MJ11/MM11

TECHNICAL
INFORMATION
DEC CONFIDENTIAL

EP-MJ11-00-TI-A

JAN 1977

Title MM11-E and F MEMORY ADDRESS SELECTION AND INTERLEAVING		Tech Tip Number MM11-TT #7	
All	Processor Applicability	Author Chuck Dewey	Rev 0
		Approval Chuck Dewey	Date 9/28/72
			Cross Reference

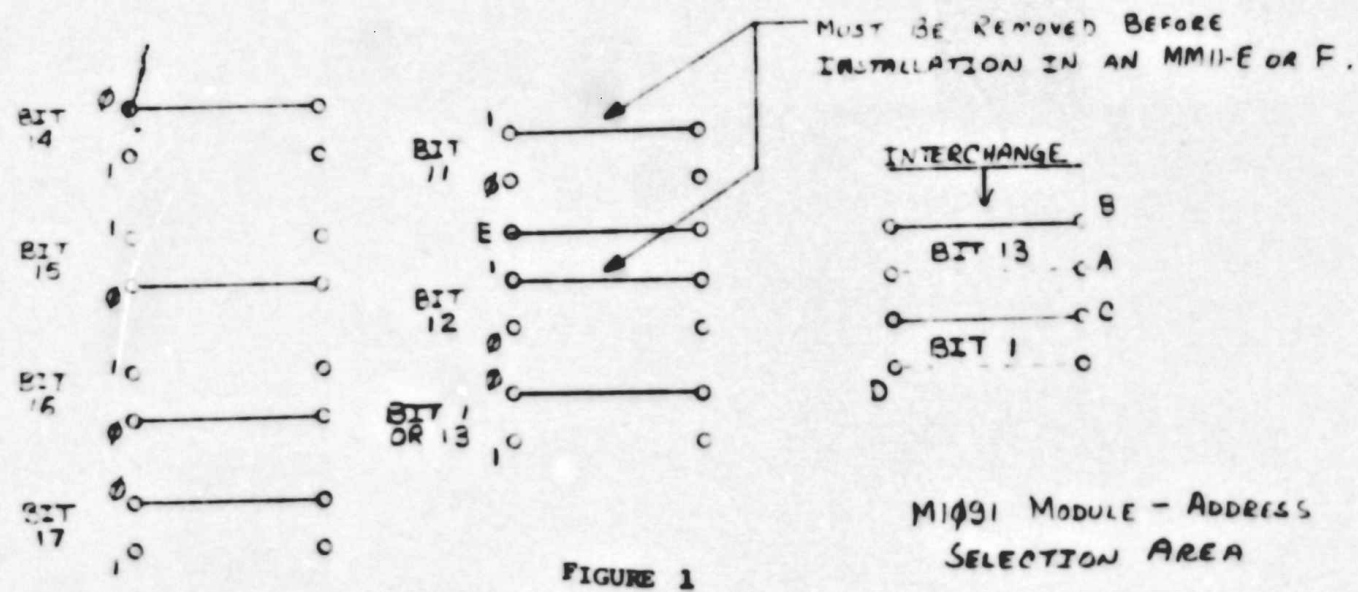
MM11-F interleaving is accomplished by manipulation of jumper wires on the M1091 module. These changes are shown in Table 1. It is a normal procedure for the production line to interleave all 8K segments of MM11-F memory on the initial system prior to shipment.

Interleaving of a MM11-E with an MM11-F is not recommended primarily due to the confusion it creates when troubleshooting a system of this nature. It also creates customer misunderstanding since the average memory cycle time specification, in this situation, would not be either the MM11-E or F but somewhere in between.

FIGURE 2

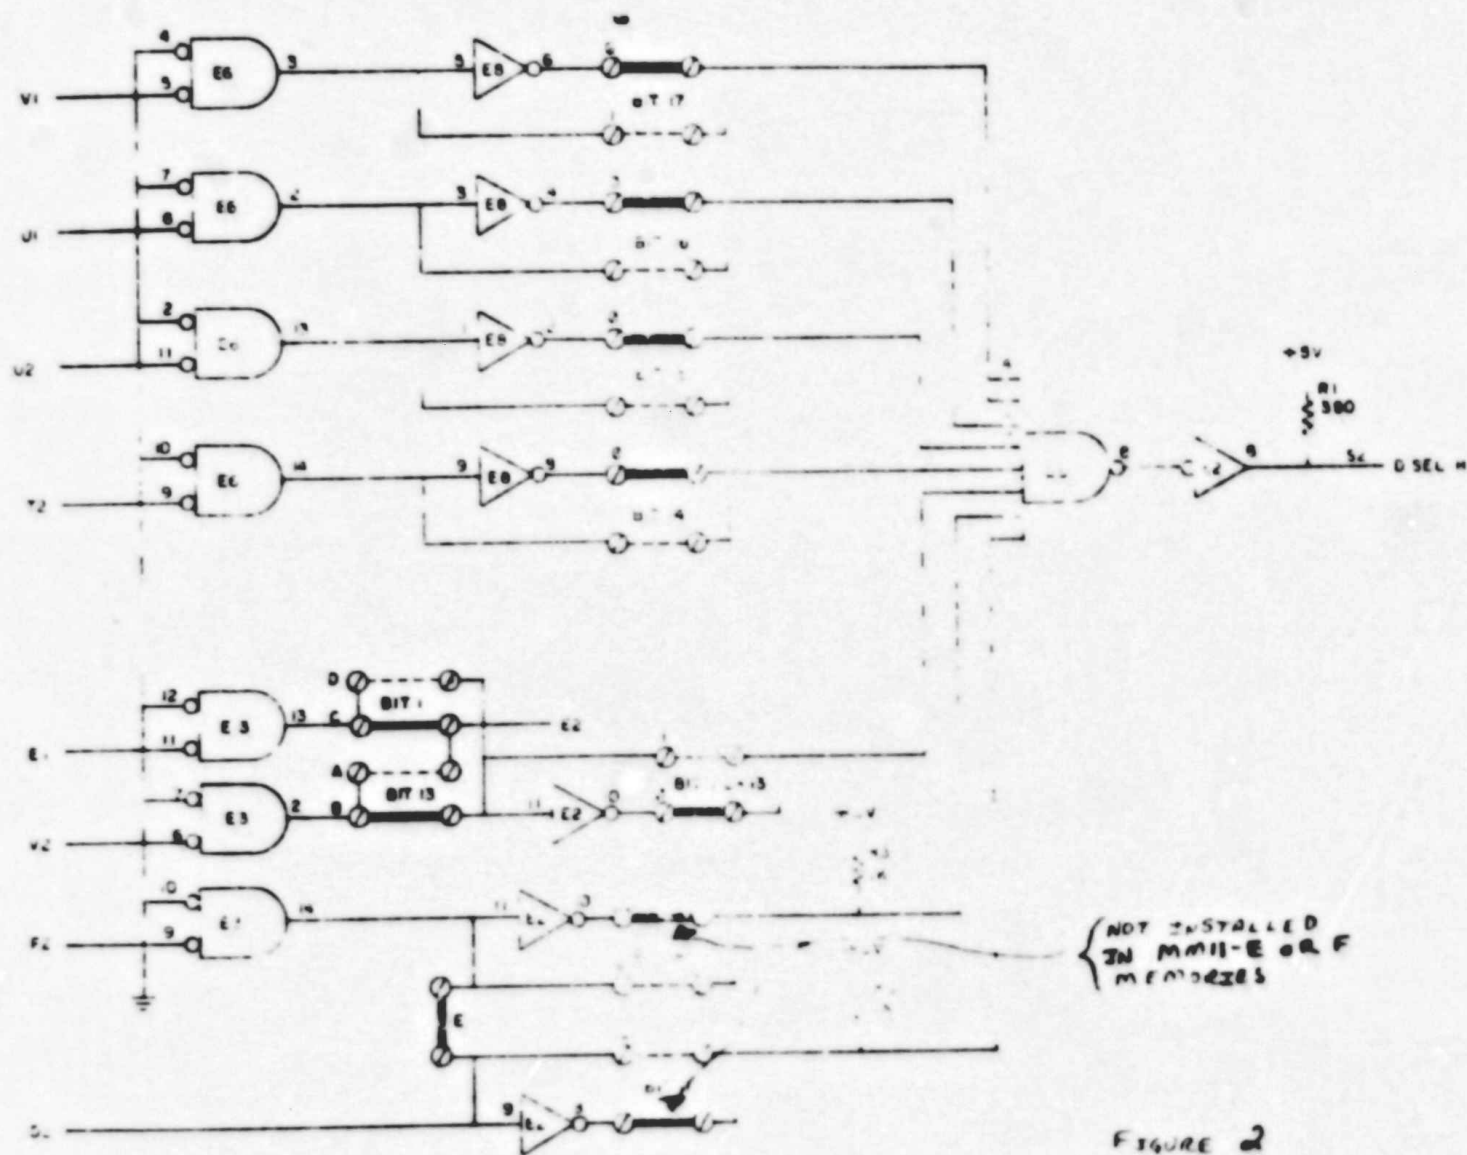
Both the MM11-E and MM11-F memories now utilize M1091 address selector modules. Figure 2 shows the circuit schematic of the M1091 address selection logic. Figure 1 shows a layout of that portion of the physical module where the addressing is accomplished by insertion or removal of jumper wires. Table 1 lists the following:

- d. Bits 17, 16, 15, 14, 13 and 01 Non-Interleaved
These columns show, by an X, that jumper which should be installed in order to respond to a specific memory bank addressing. The 1, 0, A, B, C and D correspond to the identification shown on the module, figure 1, and figure 2.

Title		MM11 L, S, K Memory Address Decode		Tech Tip Number		MM-TT-13	
All	Processor Applicability		Author	John Alston	Rev	ø	Cross Reference
			Approval	B. Dimbat	Date	6/1/73

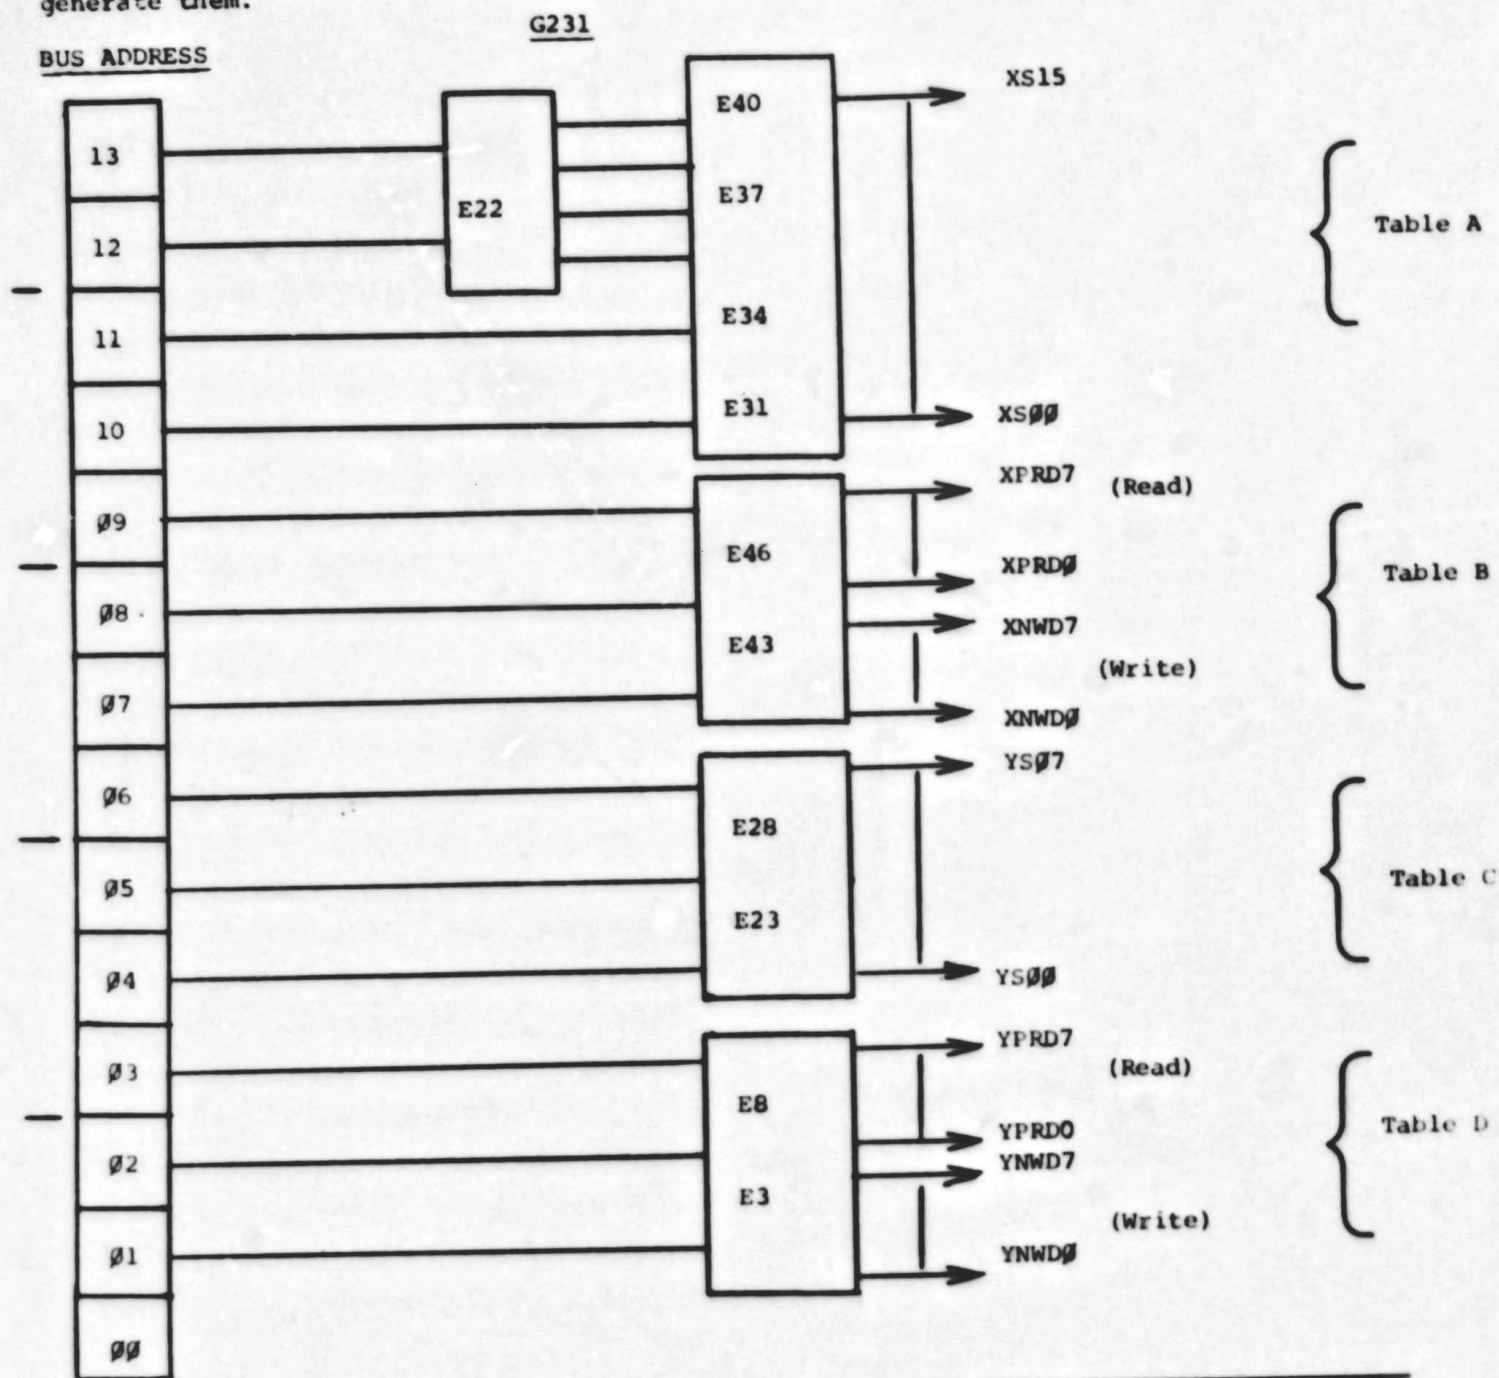
The diagram and tables supplied here are to aid F/S men when they are troubleshooting MM11L, S & K memories by relating the drive signals on the G231 with the addresses that generate them.

ECO# MM11E-00016 D-AD-7006468-0-0

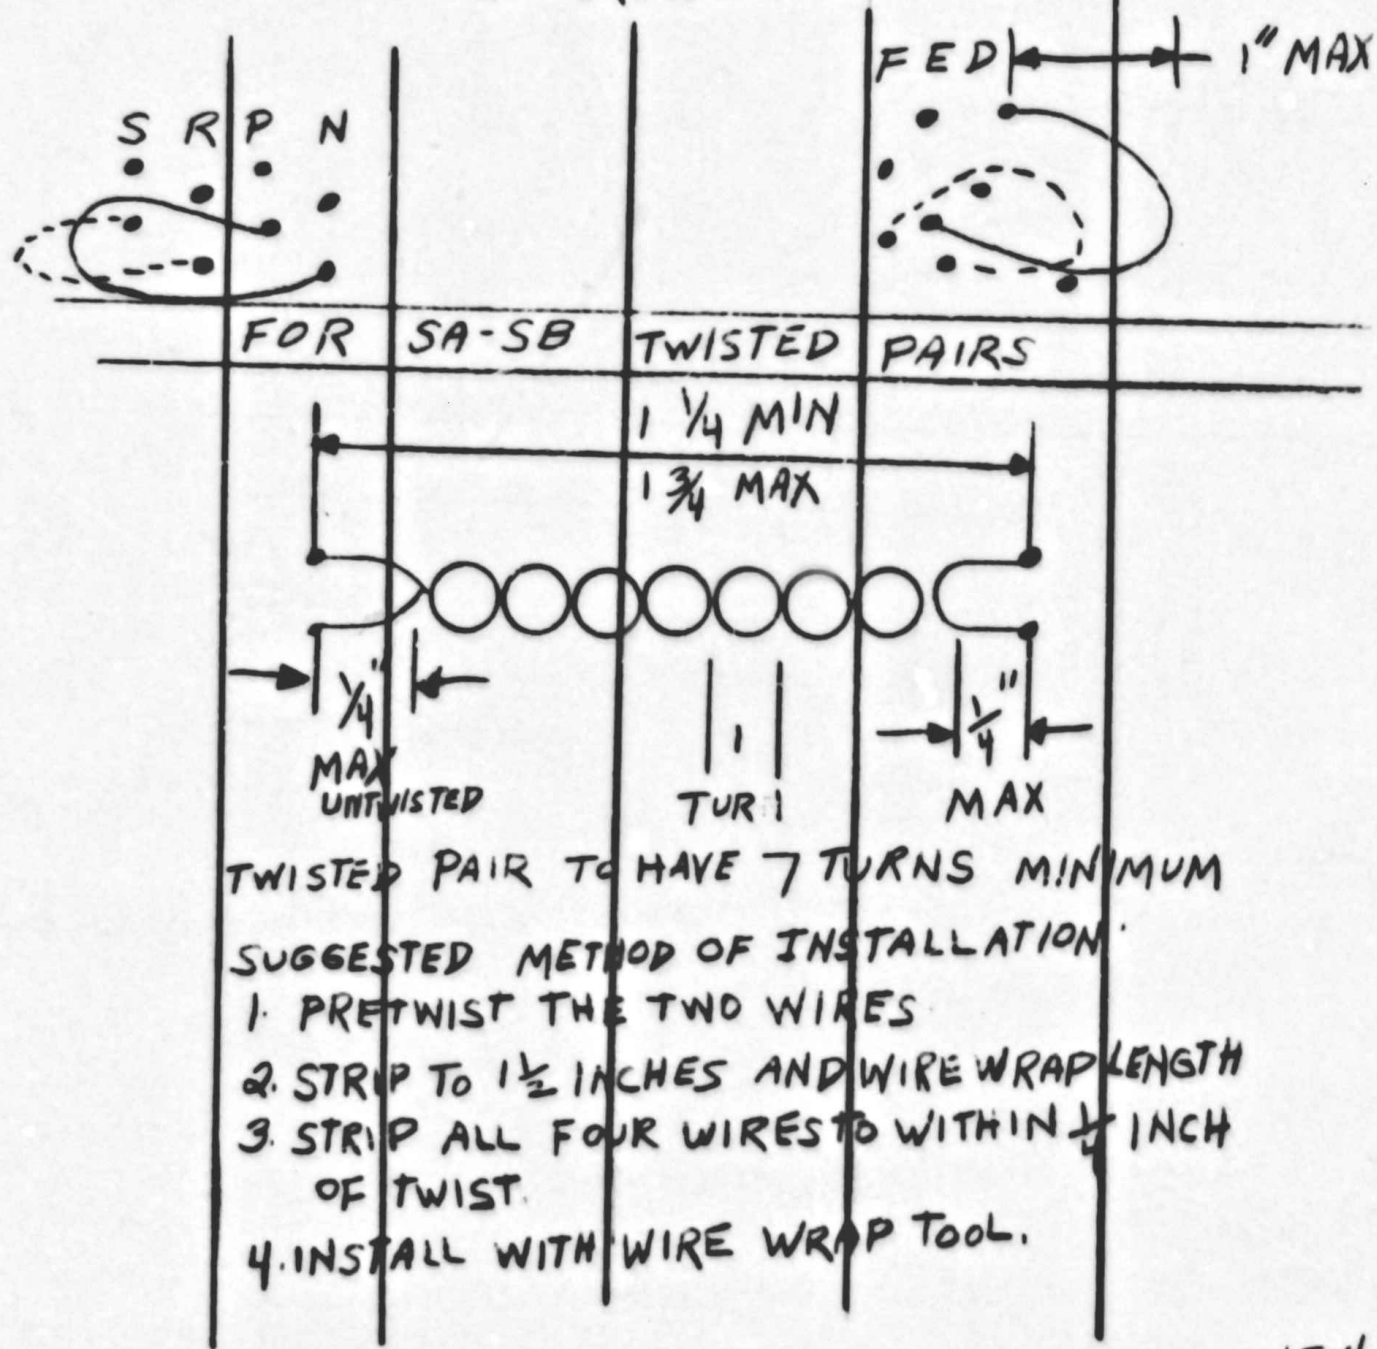
LENGTH SHOULD BE A MAXIMUM OF
 $2\frac{1}{4}$ INCHES. CHECK DRAWING FOR
 LENGTH AND FOR HOW LOOPS SHOULD
 BE DRESSED INTO LOGIC.

ECO# MM11E-00017

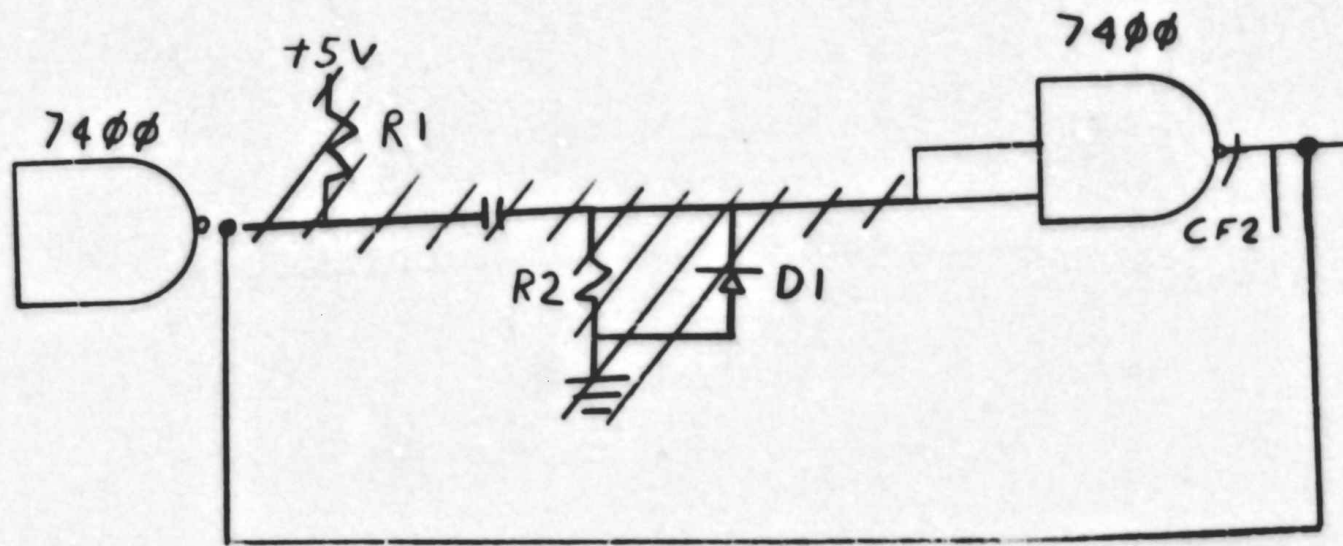
1. CHANGED TEST PROCEDURE TO IMPROVE MEMORY PERFORMANCE.
2. CORRECT WIRE LIST ACCORDING TO SUBMITTED ADD/DELETE SHEET.
3. UPDATE BLOCK SCHEMATIC PER ATTACHED MARKED UP PRINT.
4. UPDATE TIMING AND FLOW DIAGRAM AS INDICATED .
5. REMOVE WRITING FROM MARGIN.

ITEM	DOCUMENT/OR PART NUMBER	OLD REV	NEW REV	(PART NAME) DESCRIPTION OF CHANGE	DISP CODE
1	A-ML-MM11-E	P	R	(MASTER LIST) UPDATE REVISION LEVEL ON THE FOLLOWING DRAWINGS: D-BS-MM11-E-05 FROM A TO B K-WL-MM11-E-07 FROM C TO D D-TD-MM11-E-08 FROM B TO C A-SP-MM11-E-11 FROM O TO A	06
2	D-BS-MM11-E-05	A	B	(BLOCK SCHEMATIC) SEE MARKED PRINT THIS ECO.	06
3	K-WL-MM11-E-07	C	D	(WIRE LIST) SEE ADD/DELETE SHEET THIS ECO.	06
4	D-TD-MM11-E-08	B	C	(TIMING DIAGRAM) DELETE CHECK RACE COND. IN MARGIN. INCREASE TIME AND FLOW IN DISZ BEFORE 650NS. INCREASE TIME AND FLOW IN CINZ BEFORE 350 NS.	06
5	A-SP-MM11-E-11	-	A	(ENGINEERING SPECIFICATION) DELETE FROM PARA. 11.0 210 NS . ADD 220NS. ADD TO PARA. 13.4- IF THE MARGIN IS GREATER THAN 1.0V SET VXY AT 0.5 BELOW THE FAILING HIGH END POINT. (EXAMPLE IF MARGINS ARE 0.4 TO 1.8V, SET AT 1.3V= 1.8-0.5)	06

ECO MM11E-00022
MM11F REWORK SHEET

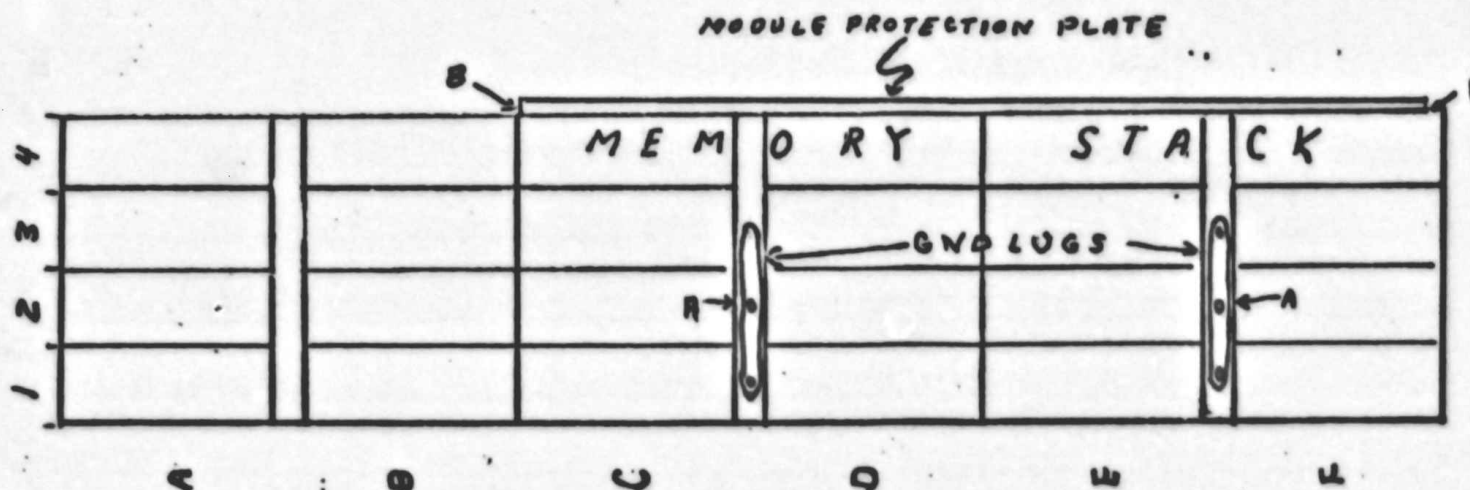
MM11E-D0022 CODE: DF ML: W
MAR 72 - PROBLEM Under some conditions, when other options are placed along side an MM11E, they fail to operate correctly.
CORRECTION: Install a module protection plate.
In-plant effectivity: Retrofit all MM11E's as required.
Field effectivity: All MM11E as required. Time To Install And Test 10 Hour.
(Kit Contents -
FCO-Prints And Parts)

2.	7408490	-	-	07	(Module Protection Plate) Add quantity of 1 to drawing index.			ORDER PR MODEL <input type="checkbox"/> YES <input checked="" type="checkbox"/> NO

ECO MMIF
MMIF REWORK SHEET

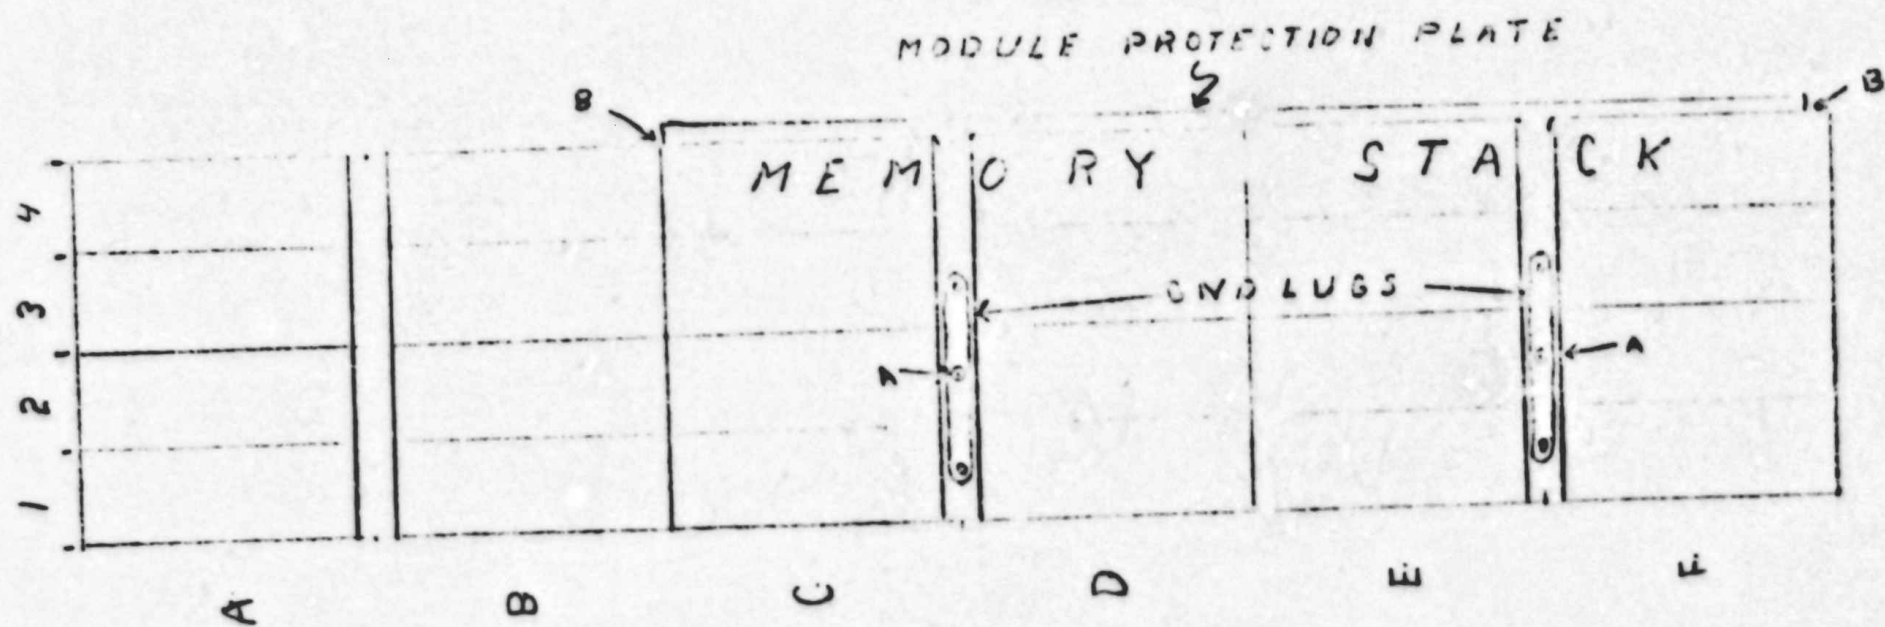
ITEM NO.	DOCUMENT/PART NO.	OLD REV	NEW REV	DISP CODE	DESCRIPTION OF CHANGE
1.	A-PL-MM11-F-0	0	A	06	(Memory Assembly MM11/F) Change per this ECO.
2.	7408490	-	-	07	(Module Protection Plate) Add quantity of 1 to drawing index.
3.	A-ML-MM11-F	0	A	06	Update per item 1.

ECO NO.
MM11F-00003
 Sheet ___ of ___

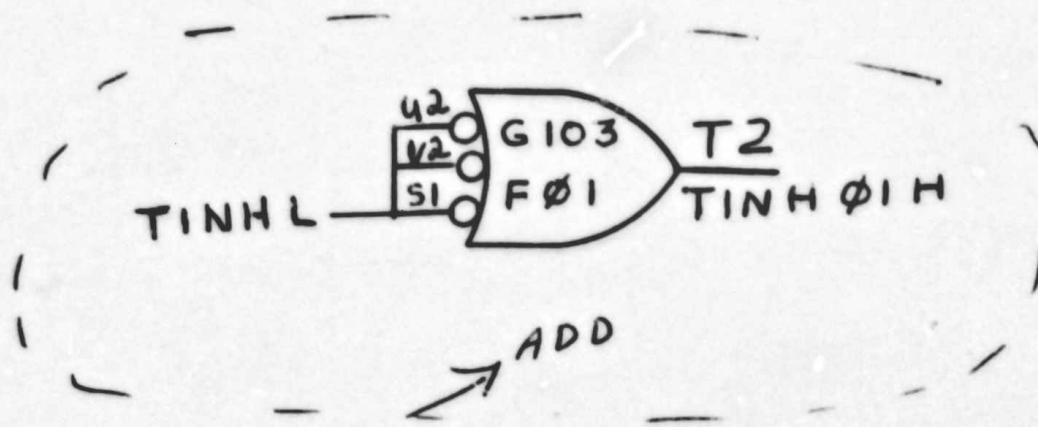
1. Strobe signals and TINH have too much noise on them.
2. Read H signal has too many loads on it.
3. Solves memory problems caused by DMA transfers that memory diagnostics don't show up, also, solves slot sensitive G103, G102 problems.

SIGNAL NAME	FROM PIN	TO PIN	COMPONENTS	ADD	DEL
TINH H	C01C1	D02E1			X
TINH H	D03E1	E03E1			X
TINH H	E01E1	F01E1			X
STROBE 00 H	C01R1	D02S1			X
STROBE 01 H	C01A1	E01S1			X
TSS H	F01V2	F01P1			X
TINH L	C01K1	F01S1		X	
TINH L	F01S1	F01U2		X	
TINH L	F01U2	F01Y2		X	
TINH 00 H	C01C1	D02E1	WHT	TWP	X
GND	C01C2	D02C2	RED		X
TINH 01 H	F01T2	F01F1	WHT	TWP	X
GND	F01T1	F01C2	RED		X
TINH 01 H	F01T2	E02E1	WHT	TWP	X
GND	F01T1	E02C2	RED		X
STROBE 00 H	C01R1	D02S1	WHT	TWP	X
GND	C01T1	D02T1	RED		X
STROBE 01 H	C01A1	E01S1	WHT	TWP	X
GND	C01C2	E01T1	RED		X
